Cottage Alteration - Long Island

Alteration and strengthening of cottage, rather than conversion to dwelling as per application.

Subject: Building permit for alterations of the
cottage of Clark A. Libbey on Island Avenue,
Long Island

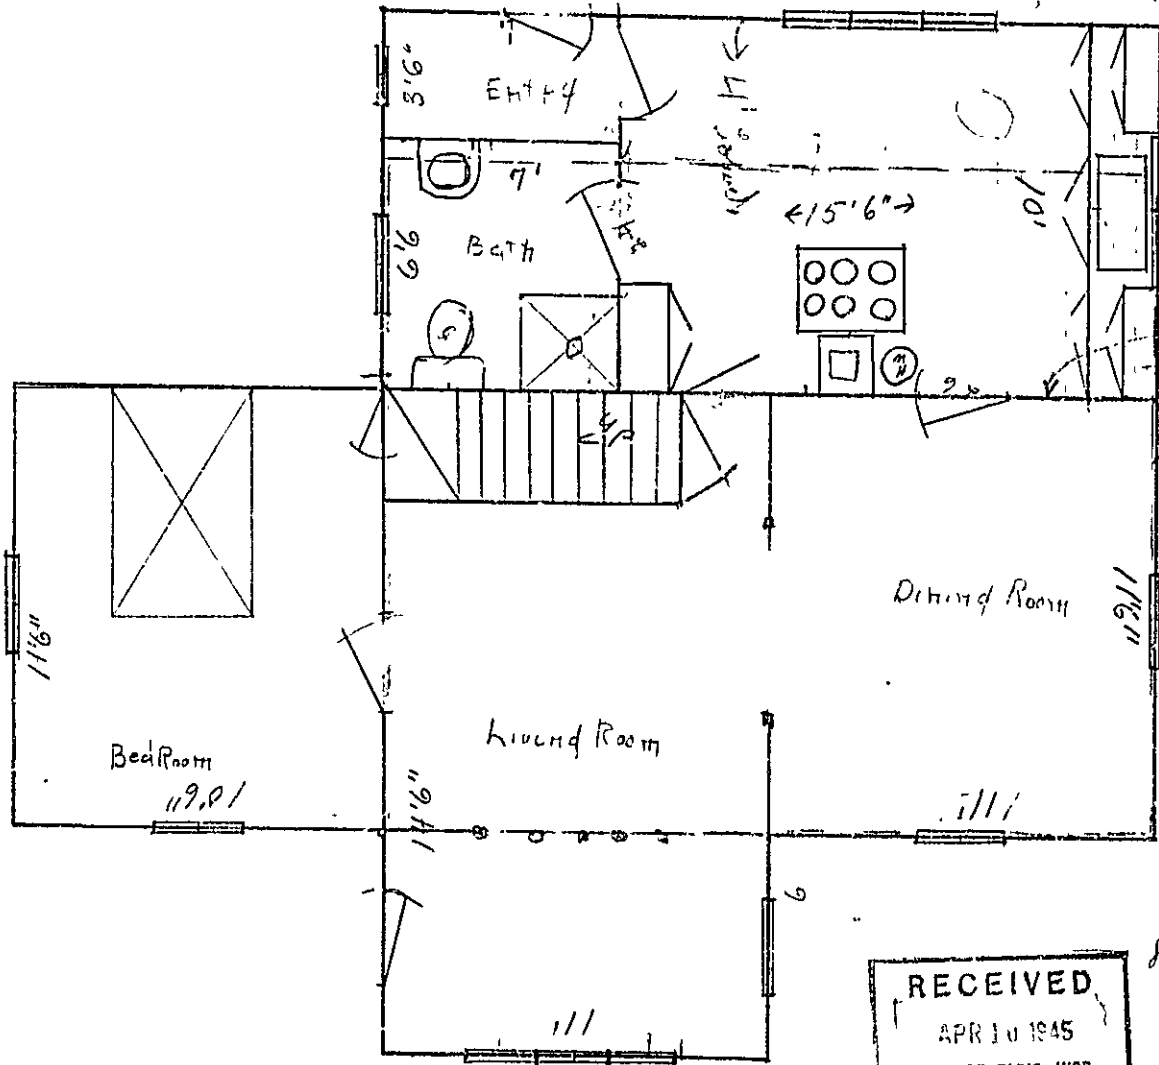
I went over this work with Mr. Libbey on location and he plans this for "long season" rather than year round work. His plans considerable repair and strengthening, a large part of which, under the circumstances, will not concern us. It is the usual cottage construction with interior partitions of sheathing.

There is a laid in mortar stone foundation, outlined in a plan, the sections outside of this are piers and one story additions sitting on posts. This structural condition could not be seen but is to be repaired as necessary by the owner.

Proper support of the rear wall of the main cottage (and of second floor over living room) are the two matters calling for special attention.

Guides include drawings of main cottage. Proposed 12' x 11'0" with 4 posts (5 spans @ 4')

It is easy to cut down to 2 posts (3 spans) at 7' spans. good for about 2900# which seems ample as cl. below no flat roof load is involved.

Mr. Libbey plans wood posts which should have proper footings.

Second floor over living room
2 x 6's 18' h.c. 15'0" span - via 4x4 or 11'0" of cor. in line
 $12 \times 11.00 = 13200 \times 8 = 105600$ (30# floor joists)

Rear wall is to be reinforced with 4x4 posts at end of span. The ground is soft so that the whole might be a bit in danger.

^{east from living room}
Second Floor 2x6-18" o.c. 11'-6" span
Good for 47¢

It would require a large girder to bring the floor over the
living room up to even 40¢

3. Proper support of the rear wall of the main cottage is one of the matters of major importance. I understand that you propose to use a 6x6 girder underneath this wall with four posts under the girder equally spaced thus making the span of the girder about four feet--this in place of an existing 2x8 laid flat supported by piers. This proposed construction appears satisfactory. Any part of the posts if below the surface of the ground ought to be of cedar or else the posts above the ground ought to be supported upon suitable masonry piers no less than eight inches square at the surface of the ground and no less than ten inches square at the bottom of the pier, the pier to extend at least 6 inches above surface of ground.

4. It is my understanding that you do not propose any finished ceilings in the cottage either now or in the future. The second floor framing over the living room--2x6 joists, 18 inches from center to center on spans of 15 feet--is such too light anyway without allowing any additional load of even the lightest ceiling. Although these joists on the long span have a 4x4 beam beneath them, the 4x4 is of little consequence by way of adding strength to the floor system. If you were ever to use the cottage for a year round dwelling, very substantial strengthening would be required for this second floor framing over the living room.
